King's Daughters

KD-3123.0-26

GC Services for UK King's Daughters Medical Center – Greenup Co. Urgent Care/Family Care Medical Office Building

ADDENDUM # 02

2 ADD ALTERNATE 3 - POWER/MECHANICAL POWER
1/4" = 1'-0"

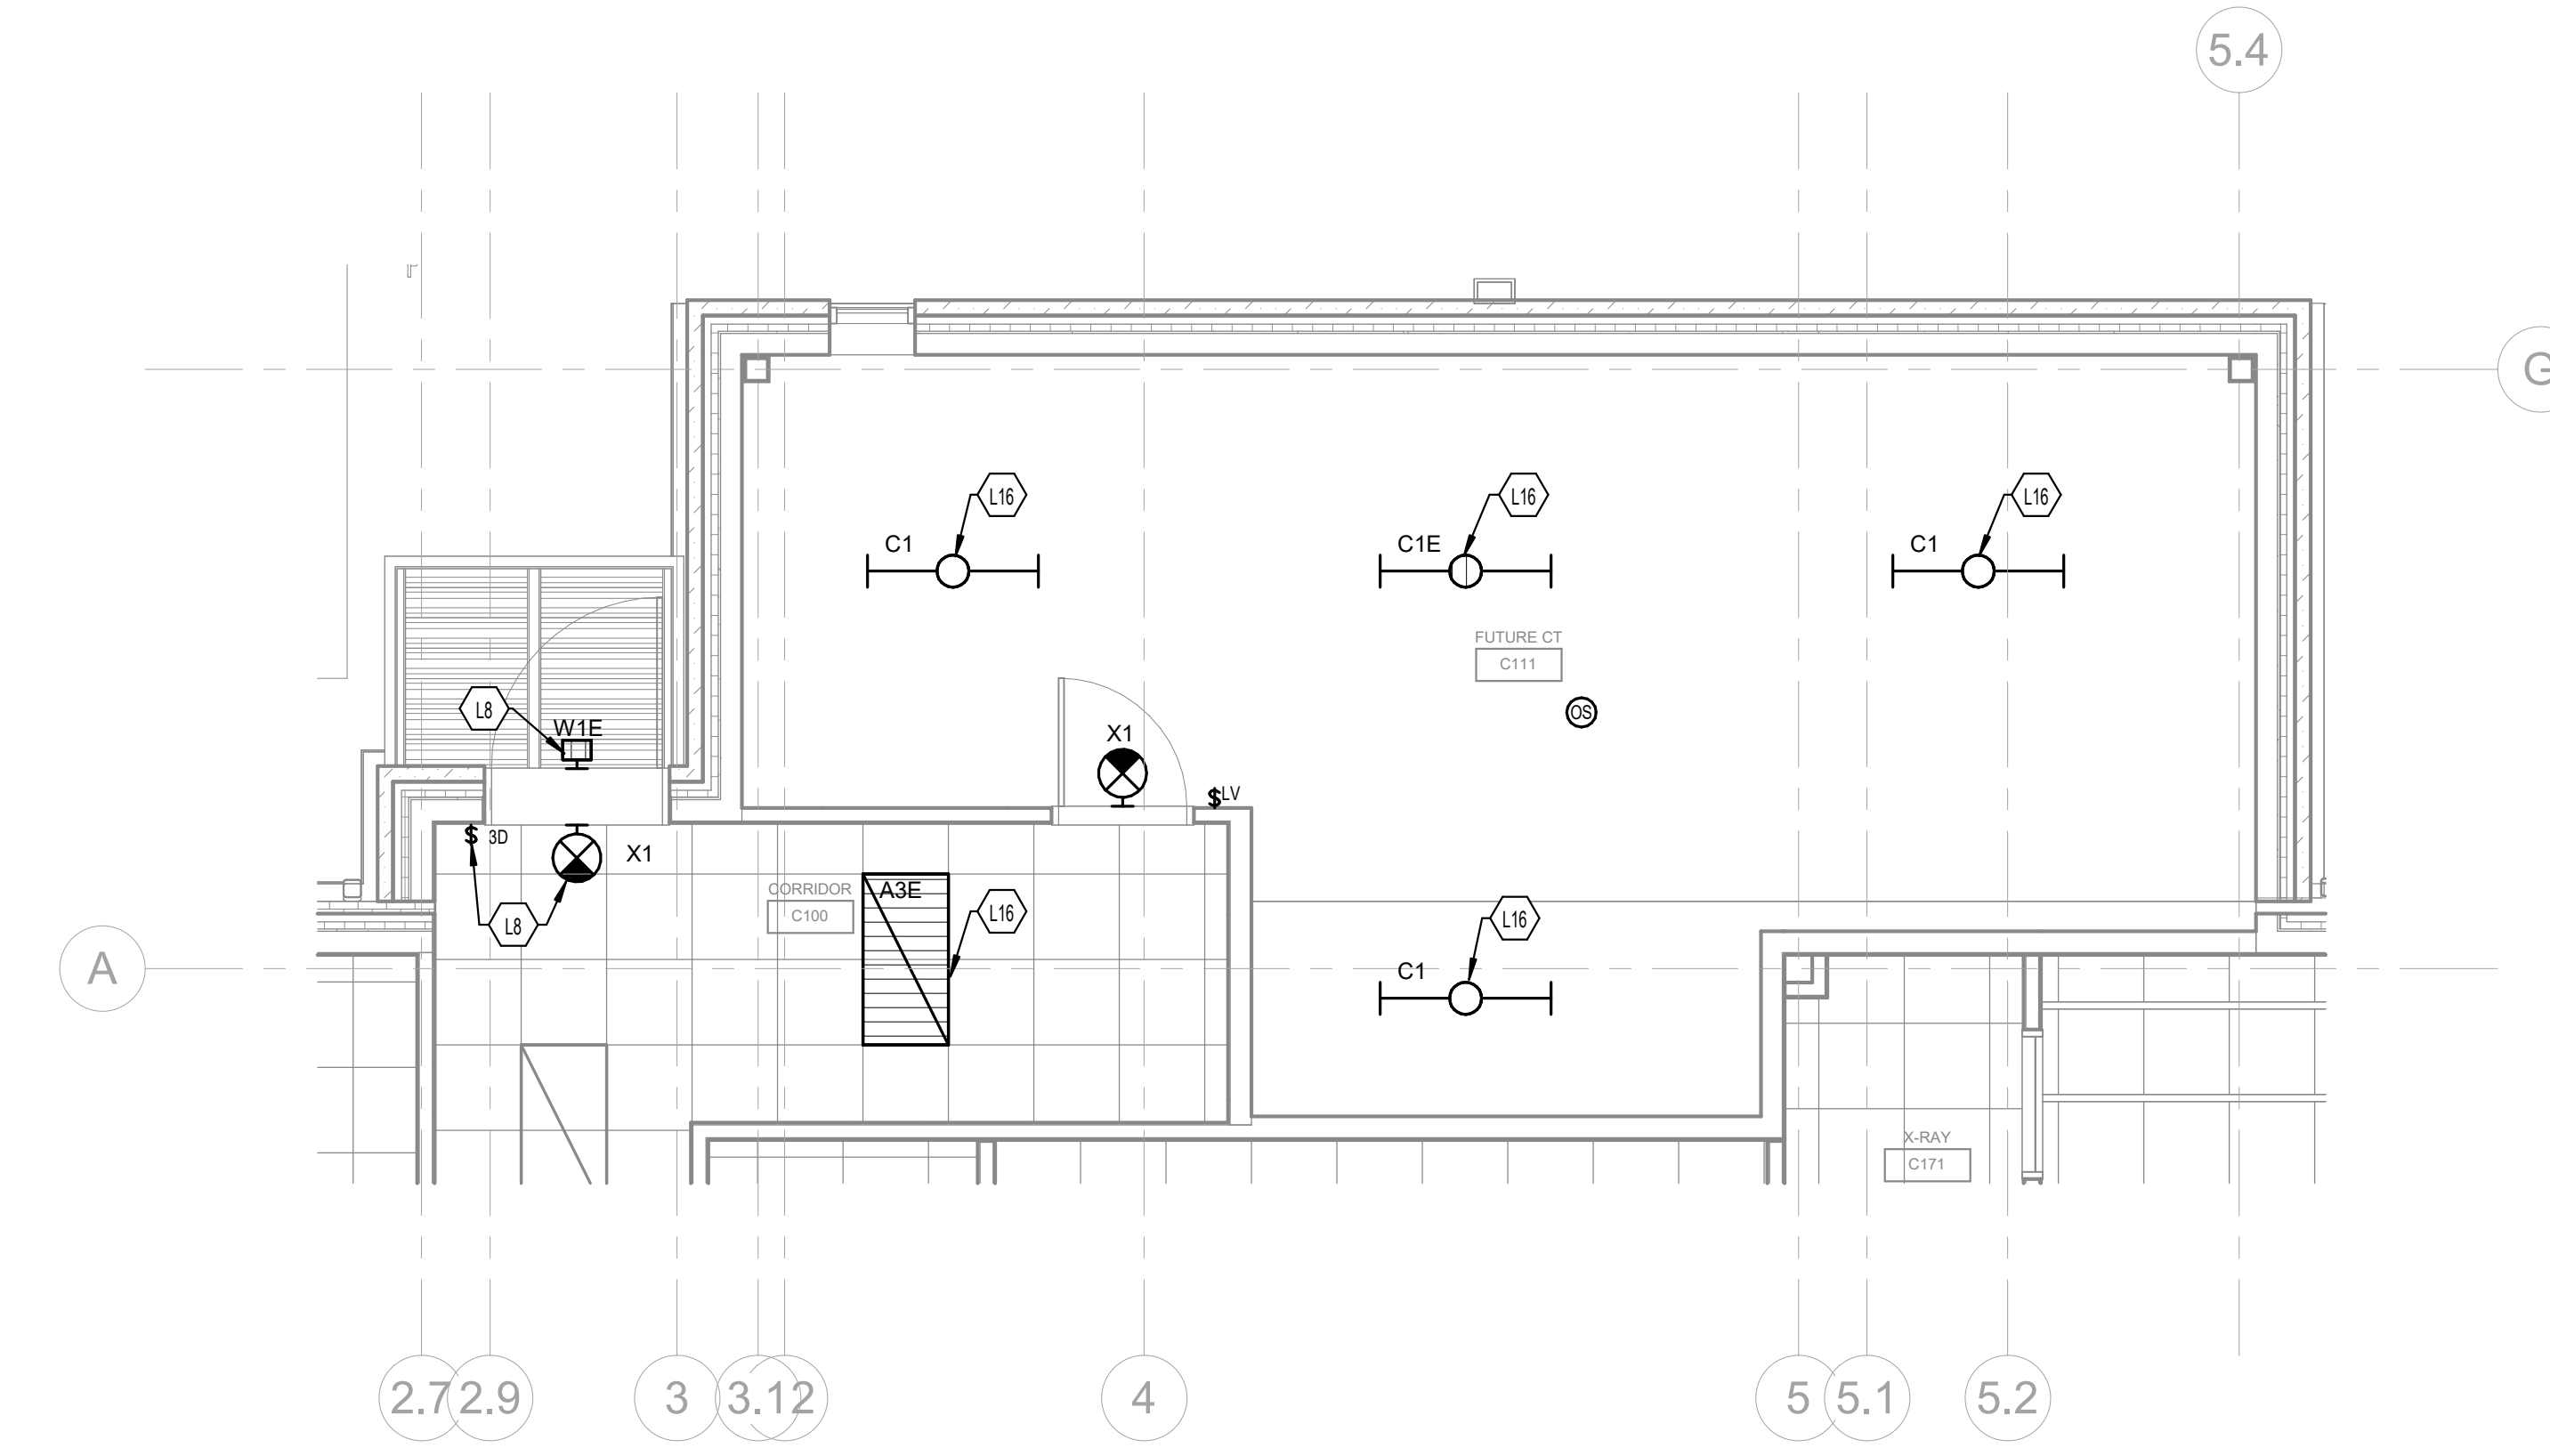
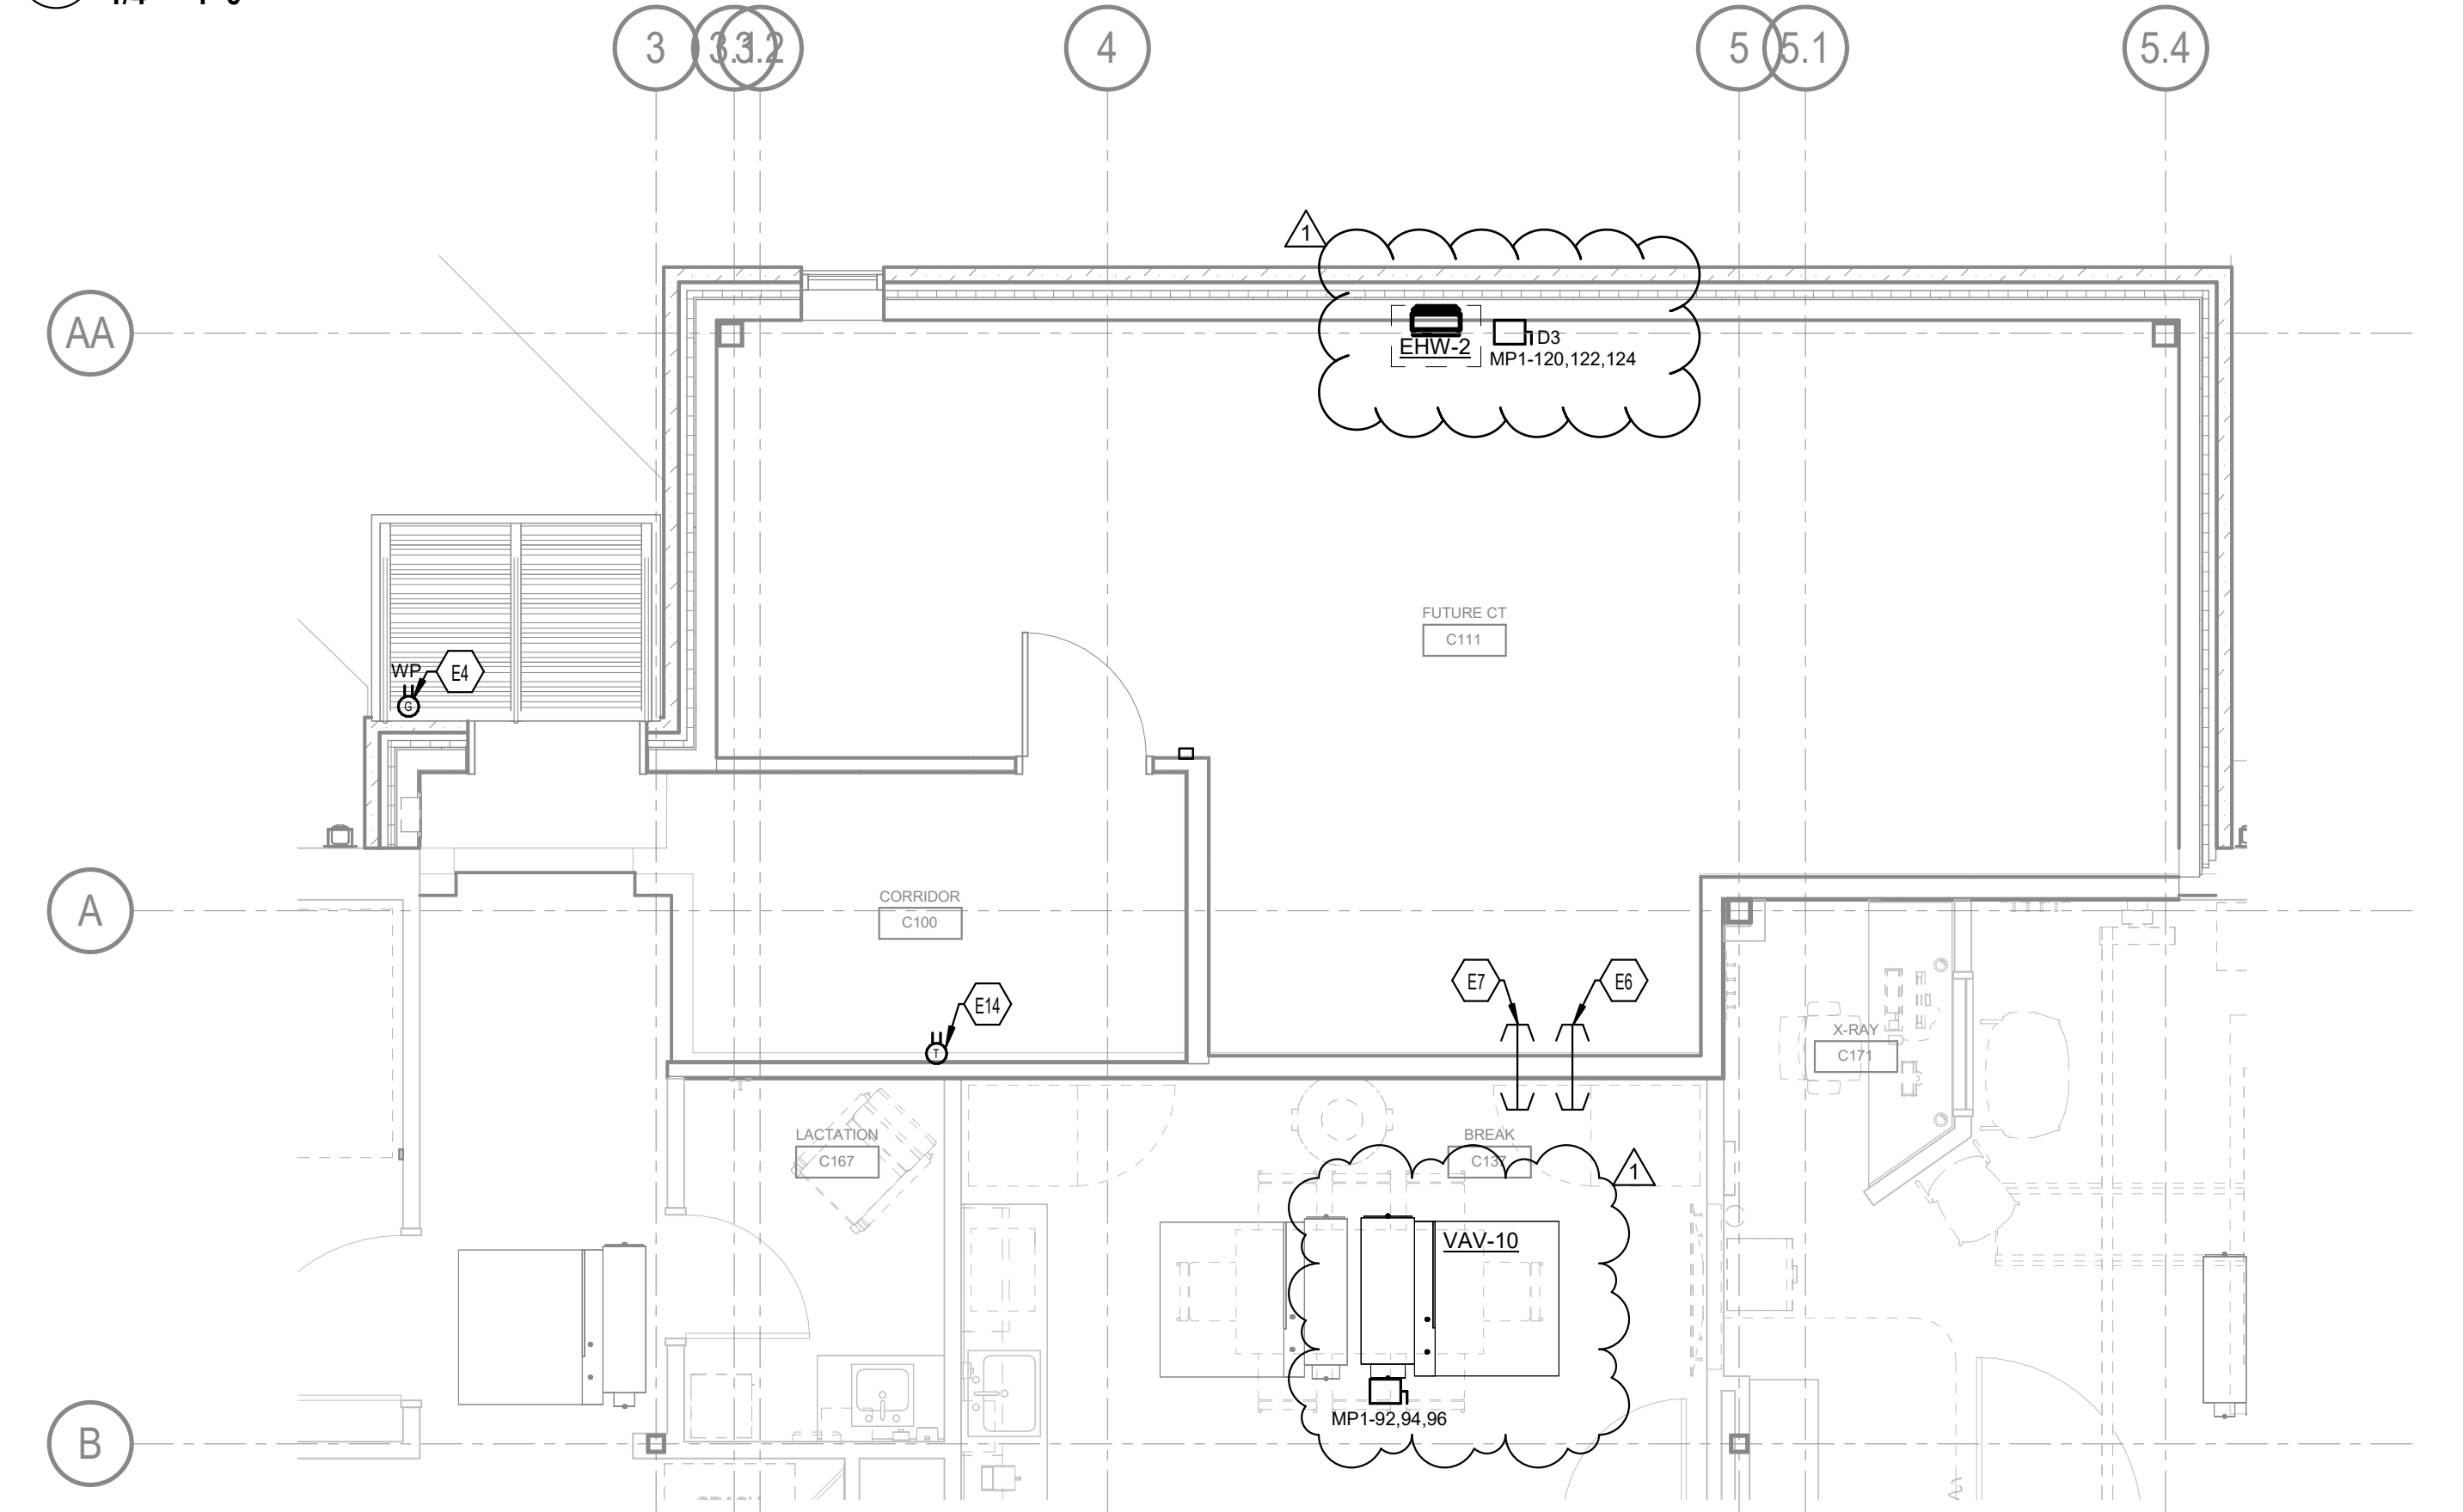
Refer to the attached revised Sheet E-601 Add Alternate 3 Plans

- View updated to show VAV-10 properly.
- Added disconnect and circuit for unit heater.
- Added disconnecting means schedule to sheet.
